Summary of Written and Oral Submissions

Zoning By-law Amendment – 433, 435 Churchill Avenue North, 468, 472 Byron Place

Document 3 - Revised Schedule YYY

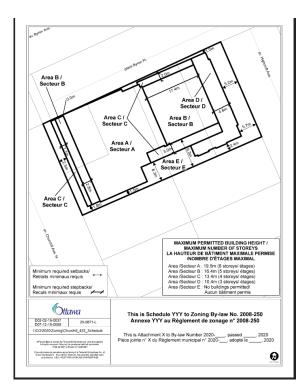
- a) Document 2, Details of Recommended Zoning, clause 3(c)(vi) be amended to replace "1.0 metre" with "1.5 metres" as it relates to the outdoor roof-top terraces; and
- b) Document 3, Schedule YYY, be amended by replacing Document 3 with the attached (see below).
